**ZONING MAP CHANGE
STAFF REPORT**

City Council Meeting Date:
October 13, 2015

Request: From: "B" Two-Family
To: "PD/UR" Planned Development for all uses in "UR" Urban Residential; site plan included

URBAN DESIGN REVIEW, ZC-15-114

Figure 1: Building Elevations

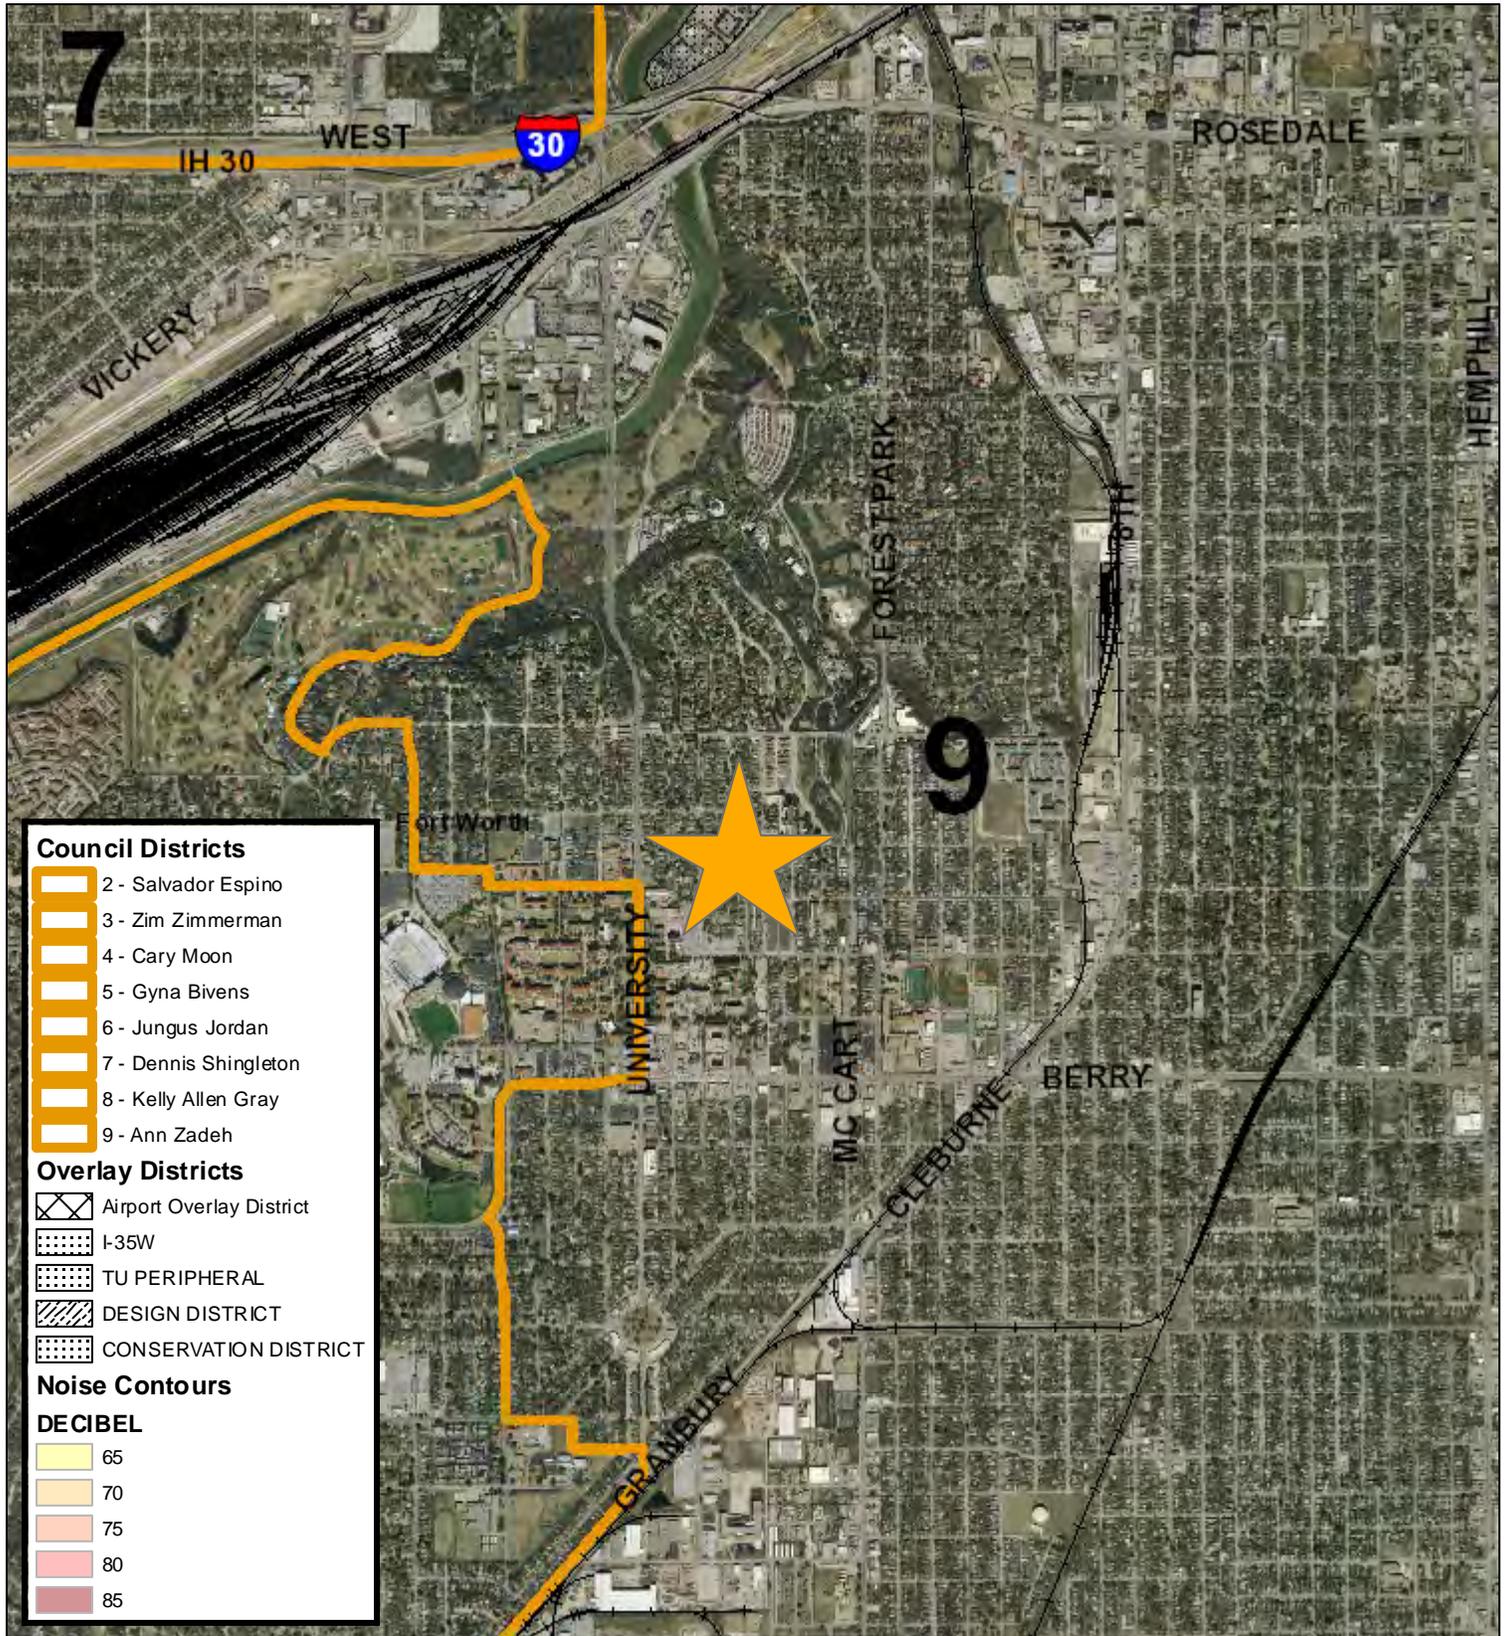
A review of the site plan submitted shows the project being in compliance with applicable UR setbacks, parking requirements, and enhanced landscaping requirements. A further review of the project's building elevations as submitted (Figure 1: Building Elevations) shows the project is in compliance with UR façade design standards, building materials and building entries. Due to the project as shown being in full compliance with applicable UR standards, design staff recommends approval of the project.

Building elevations depict the primary building entrance facing the primary street, Lubbock Avenue. Building materials consist of a mixture of stucco, brick, and hardie board siding.

01 Site Plan
 Scale: 1/8" = 1'-0"

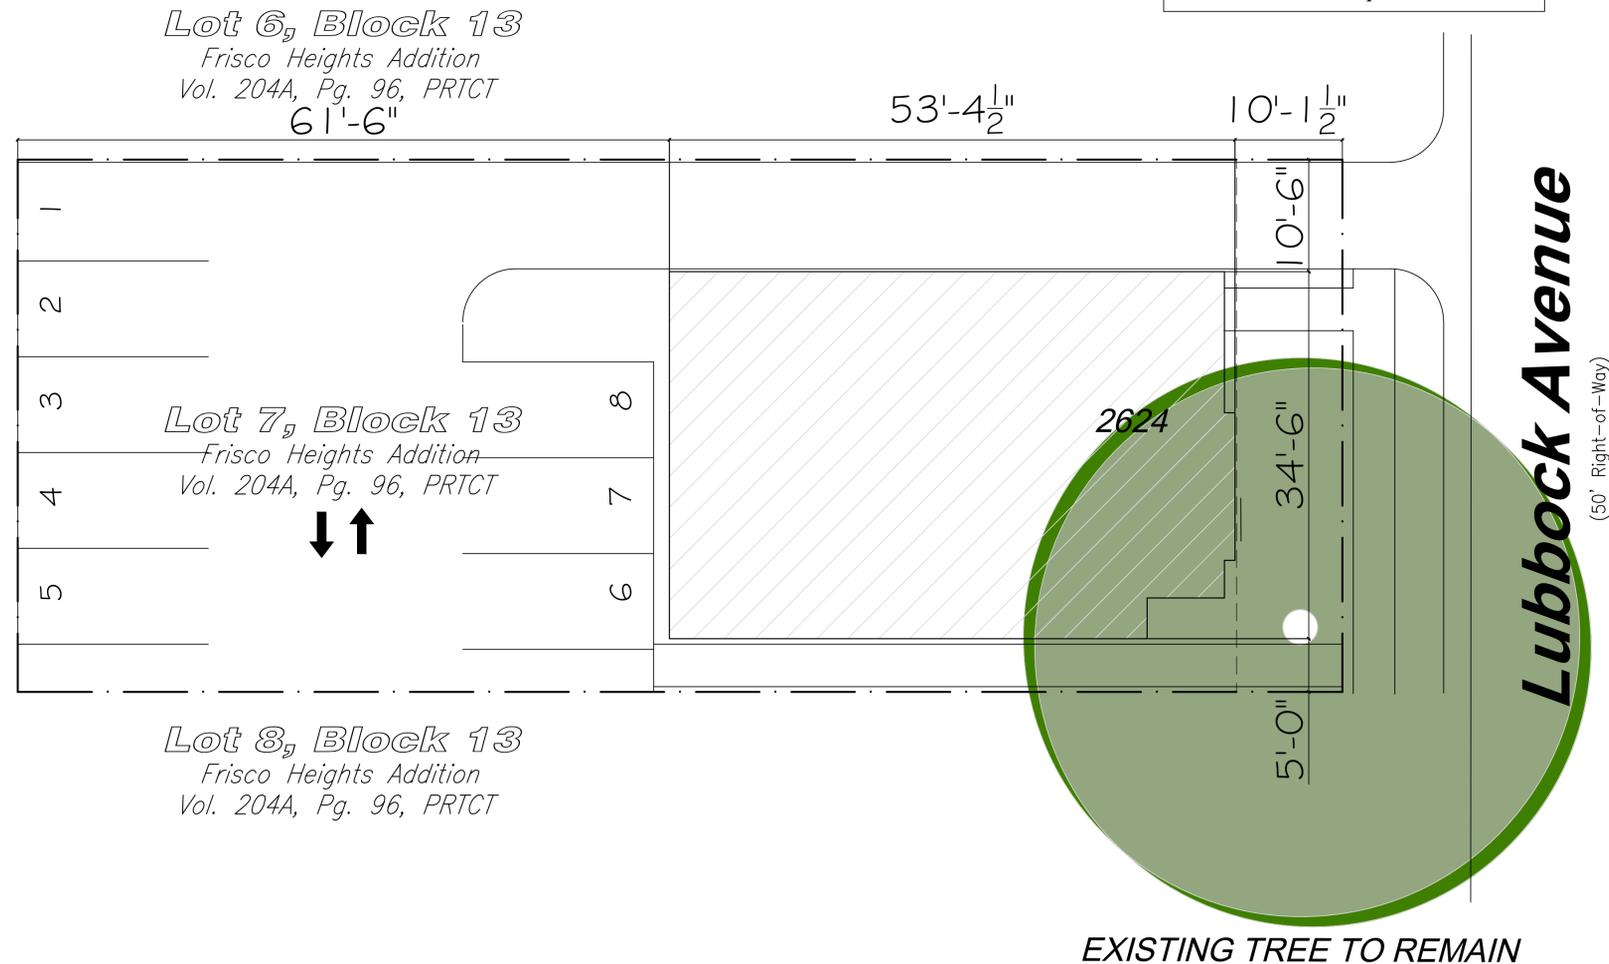
The site plan as submitted is not in general compliance with the Zoning Ordinance. A waiver is required for the following:

1. Setbacks are required when an abutting property with an existing building has windows facing to the side. Any new development or addition shall provide at least ten (10) feet of separation between the existing and new buildings (waiver is required because applicant is providing windows and less than 10 ft from an existing building)

Items noted above shall be reflected on the site plan or waivers are required
